GRAND STRAND RETINA CENTER ASC REMODEL

4310 HWY 17, MURRELLS INLET, SC 29576

FOR APPROVAL ONLY
NOT FOR CONSTRUCTION

LEVEL 2.1 FLOOR - INFILL JOIST PLACEMENT PLAN

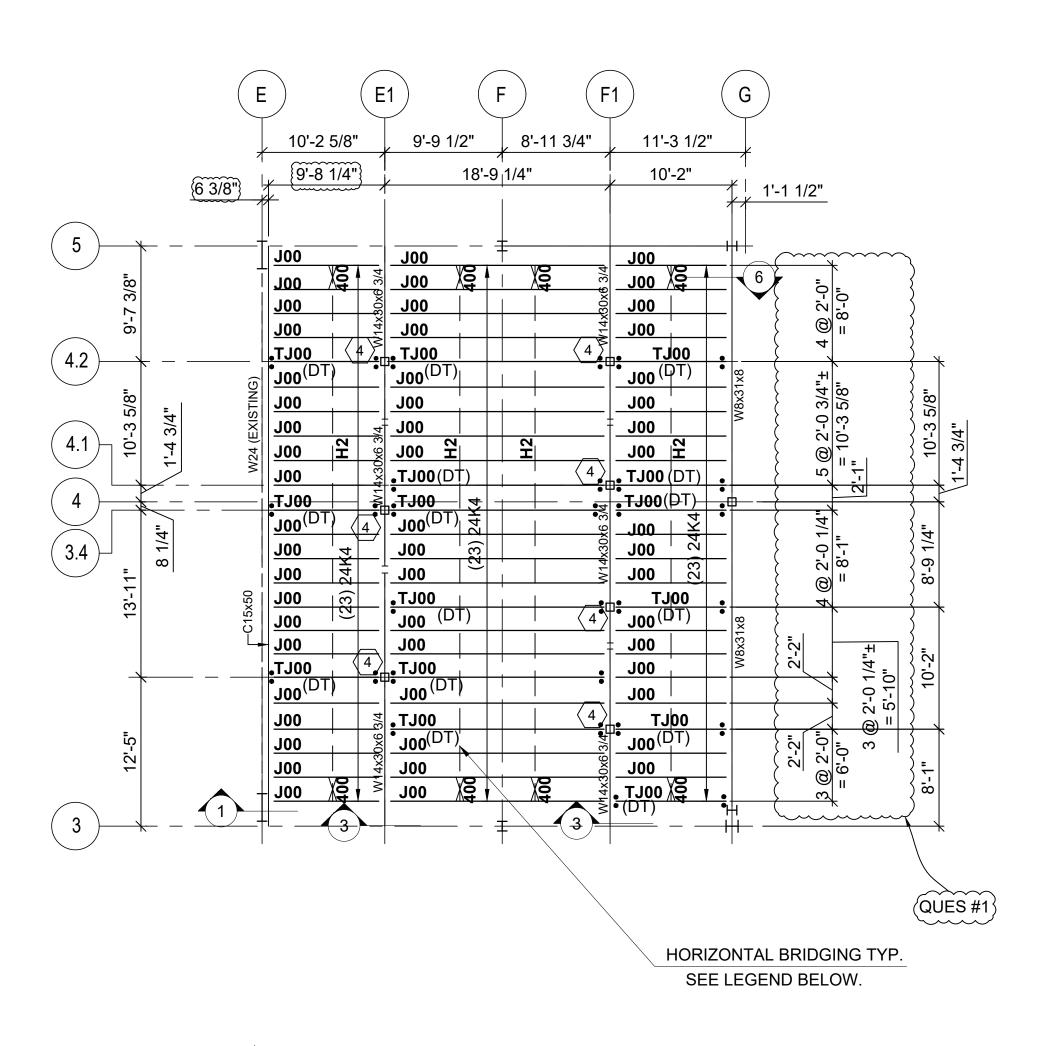
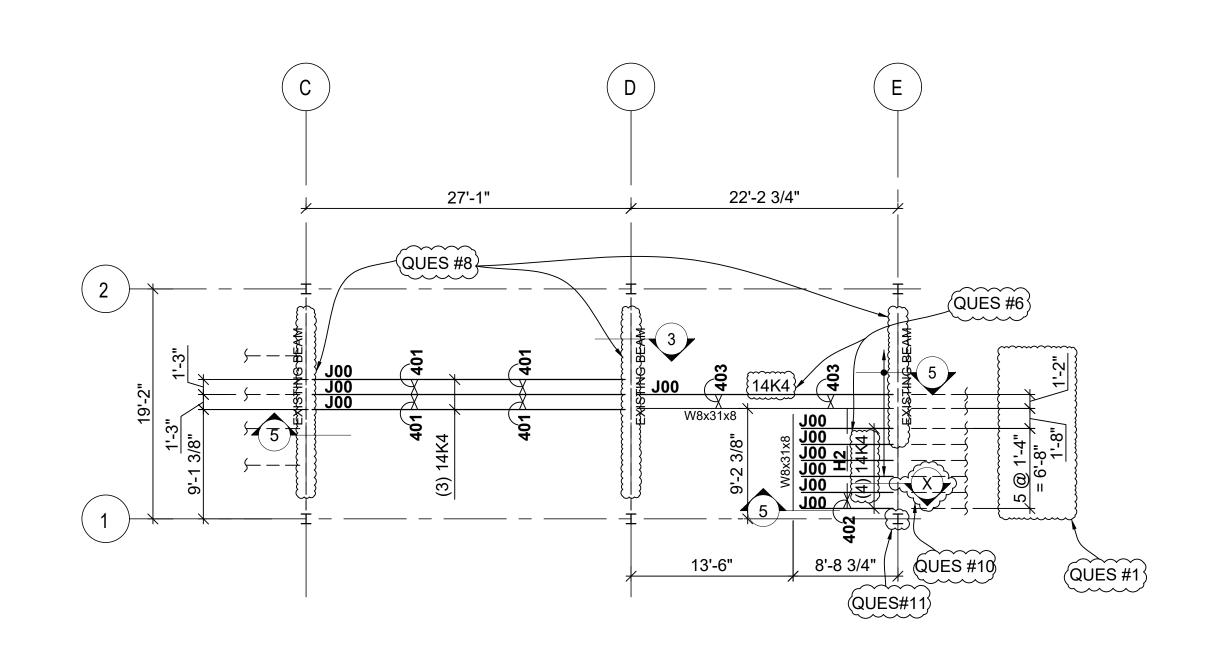
APPROVAL QUESTIONS					
QUES#	ITEM IN QUESTION	RESPONSE			
1	PLEASE VERIFY CLOUDED JOIST SPACING.				
2	NOT USED				
3	APPROVER, PLEASE VERIFY OR CONFIRM THE DIMENSIONS FROM GRID E TO CHANNEL FACE SHOWN CLOUDED ON APPROVAL DRAWING.				
4	NOT USED				
5	NOT USED				
6	APPROVER, PLEASE VERIFY/SUPPLY CLOUDED JOIST DESIGNATIONS SHOWN ON PLAN DRAWING.				
7	NOT USED				
8	PLEASE SUPPLY CLOUDED EXISTING BEAM DESIGNATIONS.				
9	PLEASE PROVIDE/CONFIRM THE EDGE OF JOIST (EOJ) VALUE.				
10	PLEASE PROVIDE THE JOIST BEARING CONDITION FOR THE CLOUDED TWO JOISTS ALONG GRID LINE E.				
11	APPROVER, PLEASE SUPPLY EXISTING COLUMN DESIGNATION.

LEVEL 2.1 FLOOR FRAMING-INFILL DECK PLACEMENT PLAN

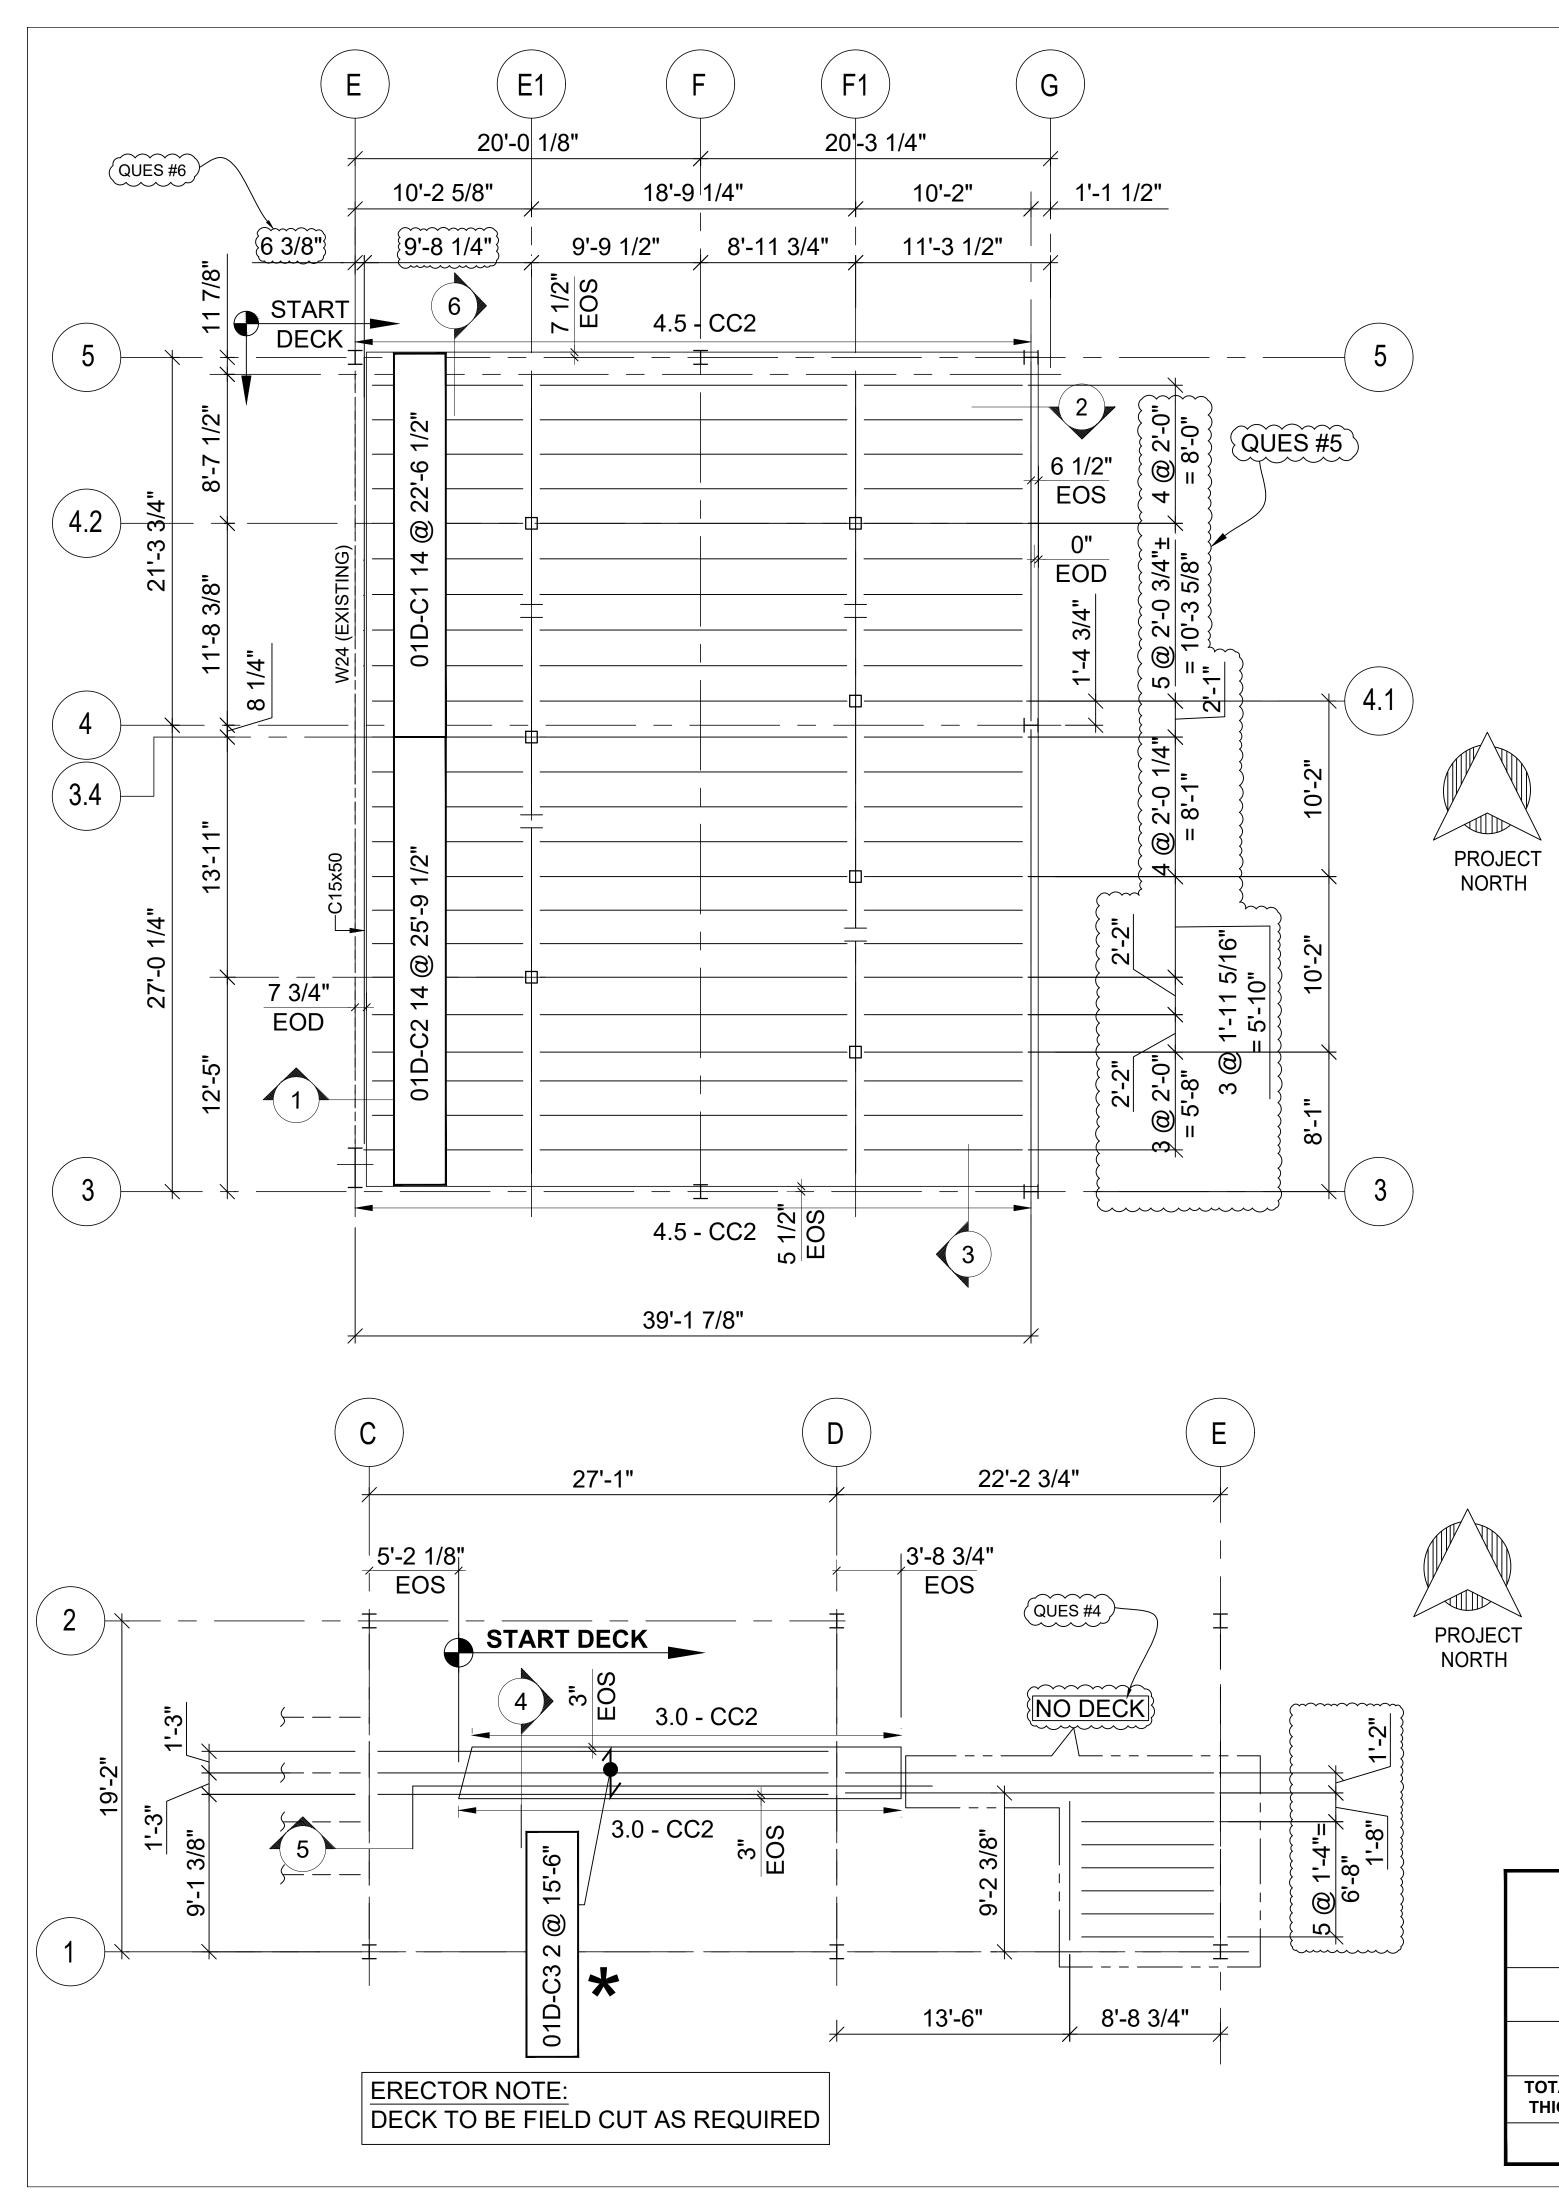
APPROVAL QUESTIONS					
QUES#	ITEM IN QUESTION	RESPONSE			
4	Approver, Please confirm there is no deck, shown clouded on plan dwgs, as per revised dwgs dated on 03/13/2024, detail #1, 4/S.303 & #1, 2, 4/S.504 not showing any metal deck at this area.				
5	Approver, Please verify or supply all joist spacing shown clouded on Approval drawing.				
6	Approver, Please verify or confirm the dimensions from grid E to channel face shown clouded on approval drawing.				
7	Approver, Please confirm as per revised dwgs dated on 03/13/2024, Roof deck (1 1/2" deck) indicate on detail #1, 2/S.304 for Level 3.1 Roof Framing on 3/S.103 is our scope of work or not. If yes then we need the information regarding deck gage, finish, ksi information along with the structural dimensions, edge of deck (EOD) dimension & fastener pattern info for this deck area.
